Access Compliance Report

Public Rights-of-Way

(Pedestrian Signals)

Intersection ID: N/A	Main Street:	Cross Street: N/A	Location: N/A
ADA ID: E4CD13B260E3	Signal Type: One Push Button-Non APS	Overall Compliance: No	Severity Score: BTN 1: N/A BTN 2: N/A No BTN: N/A
Codes/Mitigation Info/Possible Solution		Field Measurements/Component Compliance

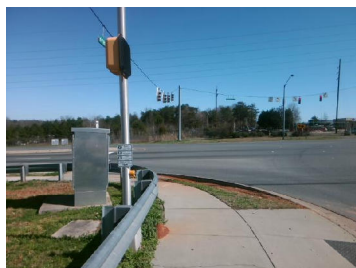
PROW/ADA: TMUTCD 4e.08, R404.2, R404.7.3, R404.7.2

N/A	B 1 Clear Xing Direction?	Yes	N/A	B 2 Clear Xing Direction?	N/A
	B 1 Crossing Direction	To SE		B 2 Crossing Direction	N/A
Yes	B 1 DistanceTo XWalk (in)	40.0	N/A	B 2 DistanceTo XWalk (in)	N/A
No	B 1 DistanceTo Curb (in)	134.0	N/A	B 2 DistanceTo Curb (in)	N/A
Yes	B 1 Diameter (in)	2.0	N/A	B 2 Diameter (in)	N/A

Possible Solutions: Replace Signal Push Button With APS Button on New Post. Remove & Relocate Sign.
